Reference: BMAA Service Bulletin 2612 issue 1
Title: Rotax 912-series cylinder head temperature measurement
Applicability: All BMAA aircraft with Rotax 912-series engine
Author: Ben Syson, BMAA
Effective date: 1 August 2016
Classification: Recommended Service Bulletin

CHT measurement (old)

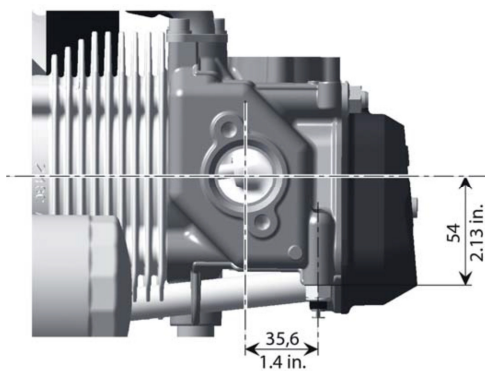
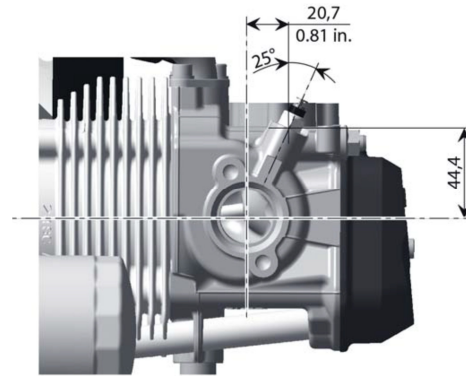
In 2013 Rotax changed the detailed design of the cylinder head on their 912-series engines (including the 912 / 912UL and 912S / 912ULS). The temperature measurement point, which used to measure cylinder-head temperature (CHT), now measures coolant temperature, which has a lower maximum temperature.

The drawings below show the old type head, which measures CHT, and the new type head, which measures coolant temperature. The new type head can be retrofitted to older engines (but is not suitable for use with waterless coolant, such as Evans’).

- Check the cylinder head whose temperature it is measuring. If it is the new type of cylinder head:
 - Change the marking of the gauge to show that it is measuring COOLANT temperature, not CHT;
 - Change the maximum temperature limit on the gauge to the maximum coolant temperature of 120°C;
 - Ensure any engine limitation placard displays the maximum coolant temperature.
